**MWO 55-1520-228-30-34**

**CHANGE No. 2**

**DEPARTMENT OF THE ARMY MODIFICATION WORK ORDER**

WIRE STRIKE PROTECTION SYSTEM (OH-58A HELICOPTER)

FIG. 1 - SHIT. 1 OF 3  
UPPER CUTTER INSTL.

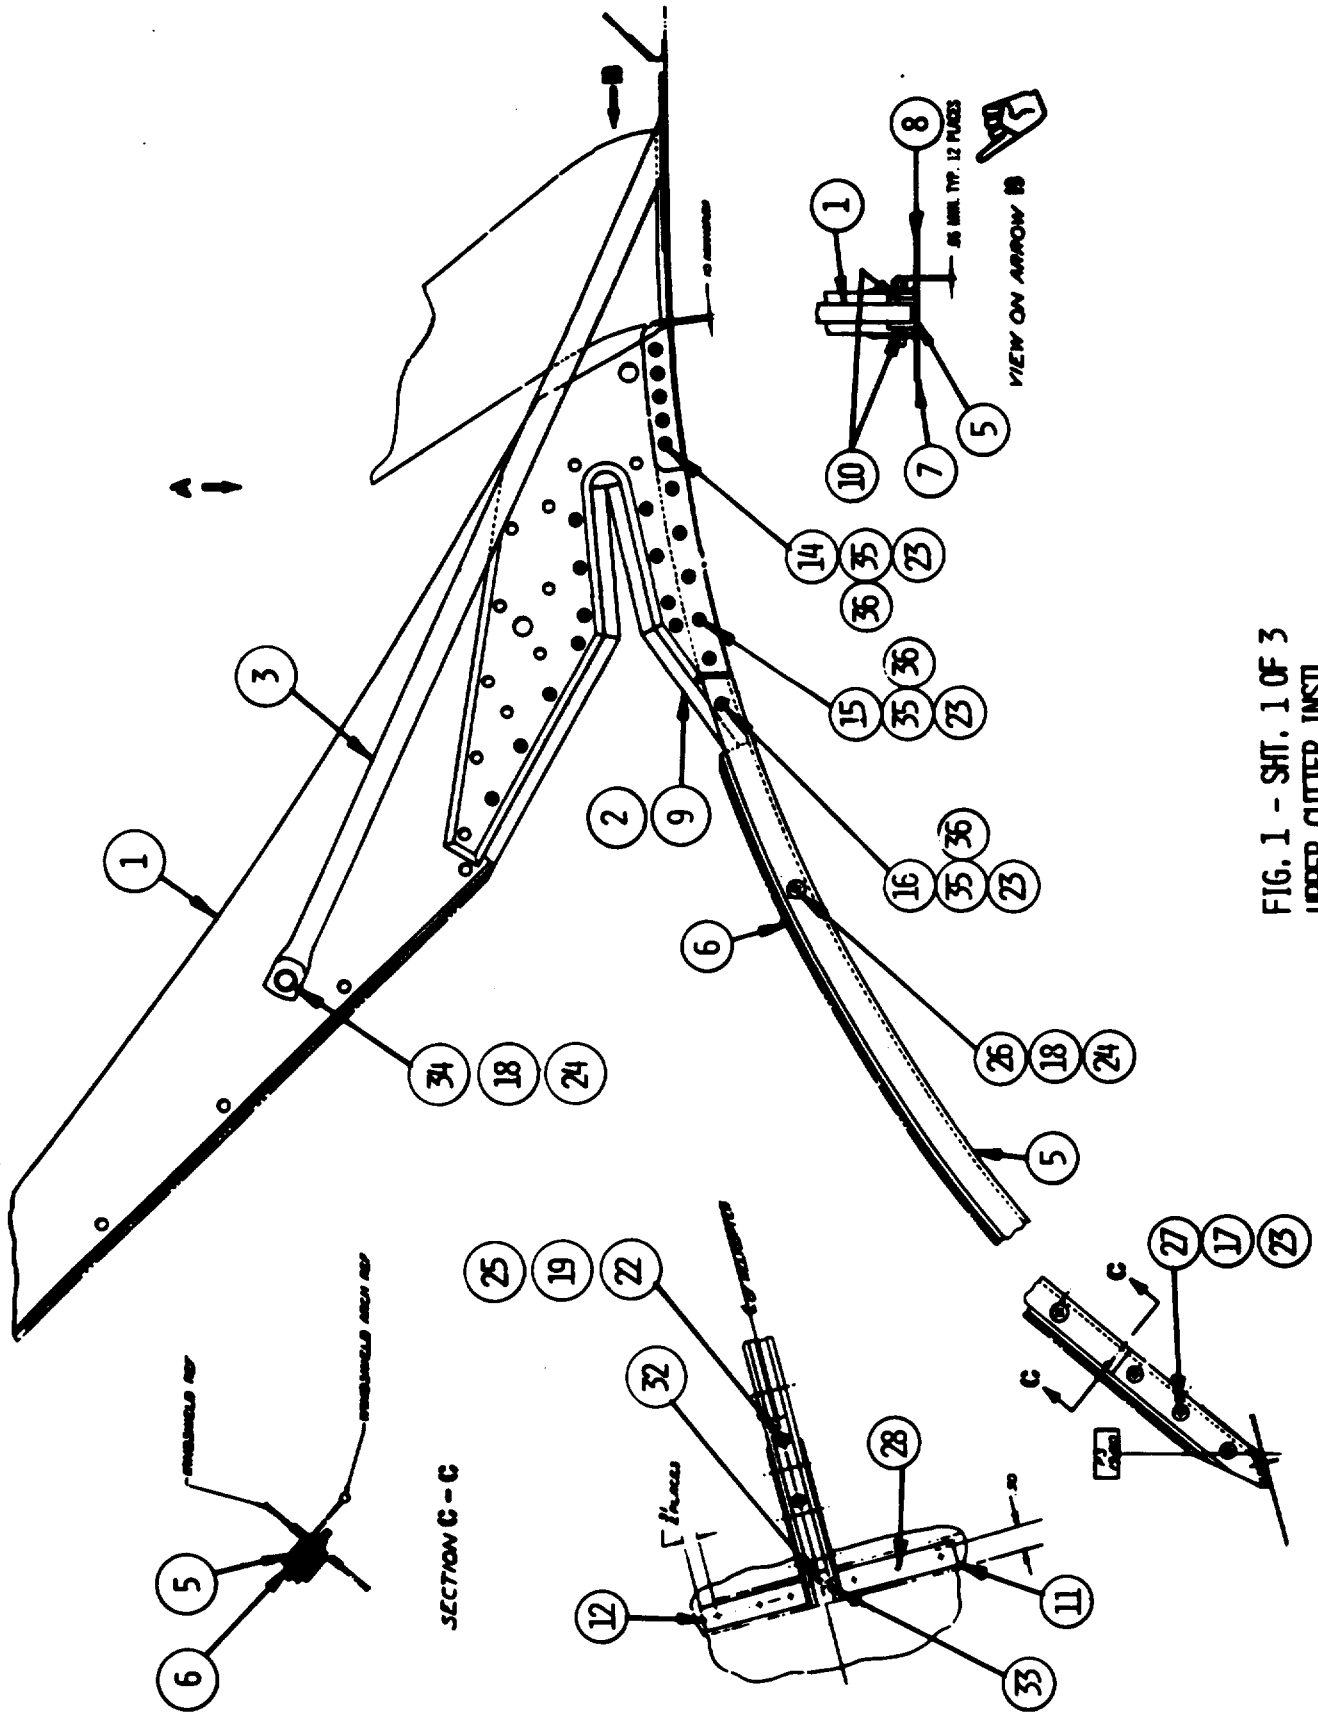
Page 10, Paragraph f (8) add at end of paragraph. Torque 990-00026 cap screws to 30-35 in lb.

Page 10, paragraph #2 add at end of paragraph. Torque 990-00026 cap screws to 30-35 in lb.

Page 12, Paragraph g. add at end of paragraph. Fay Seal all components with Pro Seal 890 before final installation.

FIG. 2 - LOWER CUTTER INSTL. - SHEET 2 OF 3

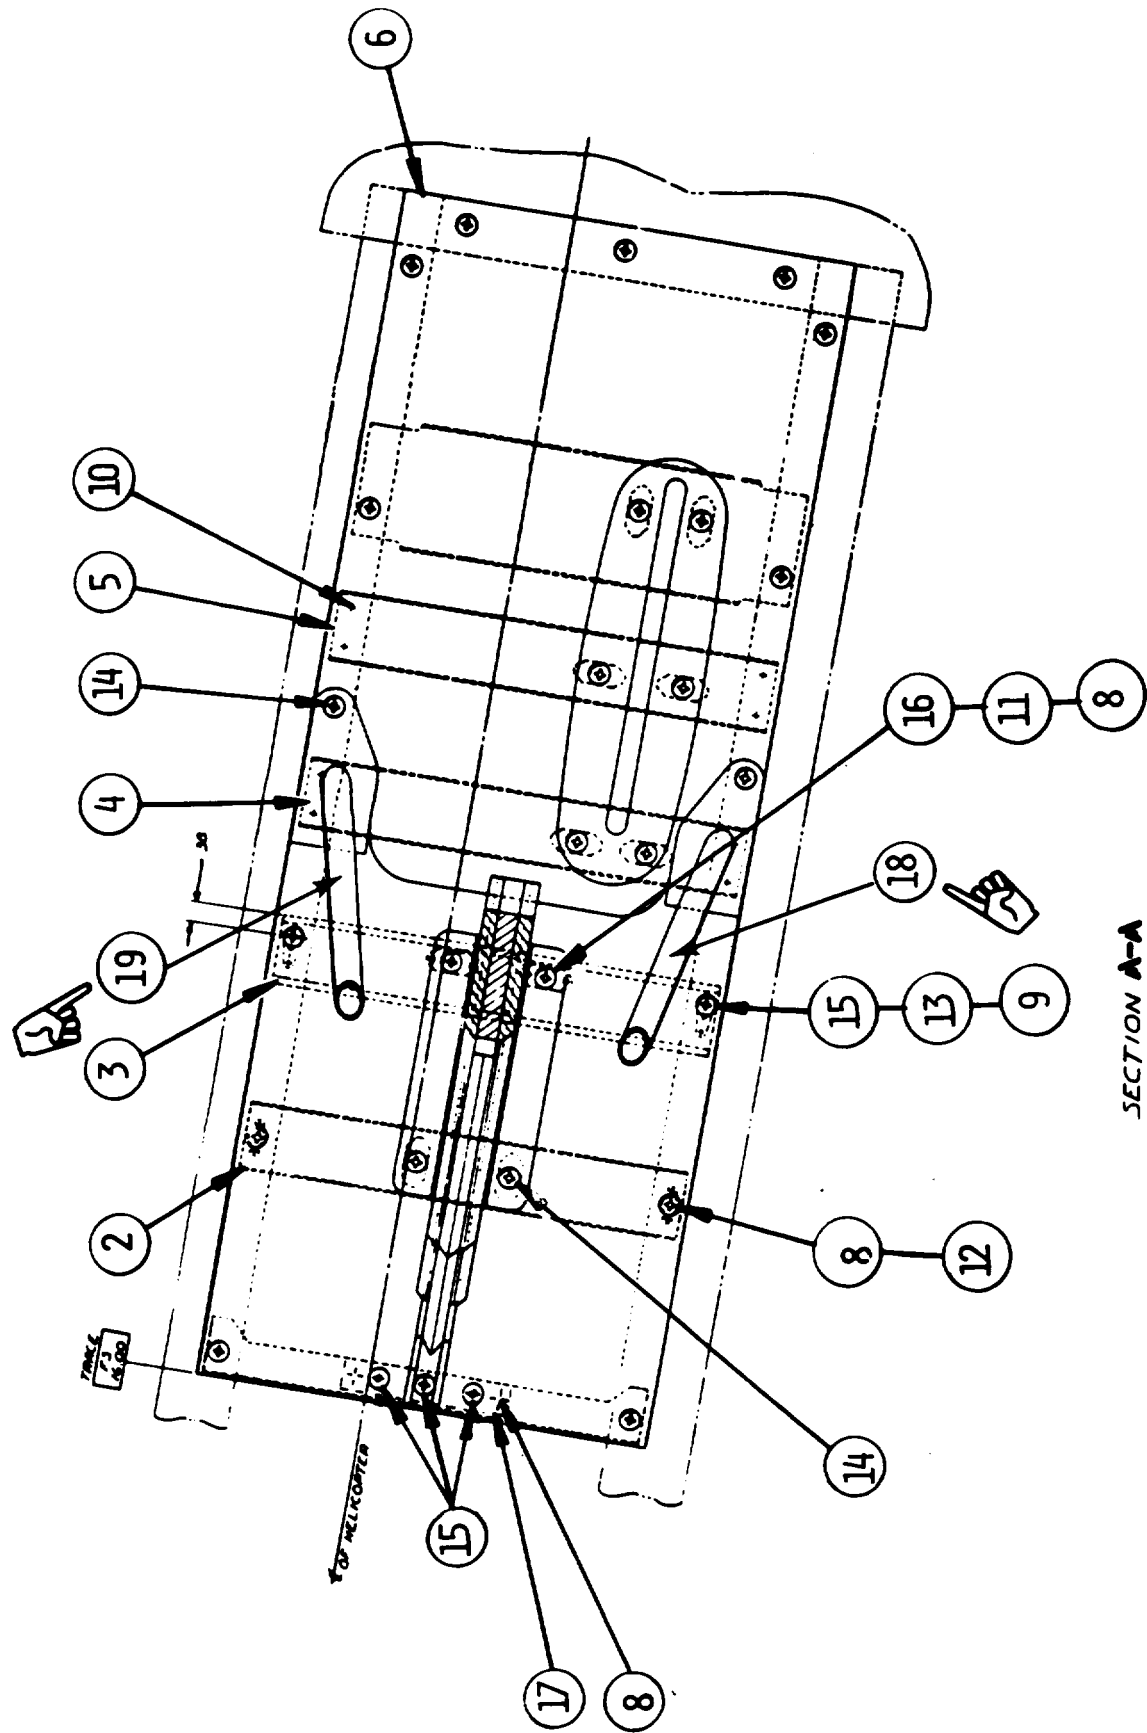
Page 19. Add item 18 to read: Strut Assy R/H (365-83015-2). Add item 19 to read: Strut Assy L/H (365-83015-1).
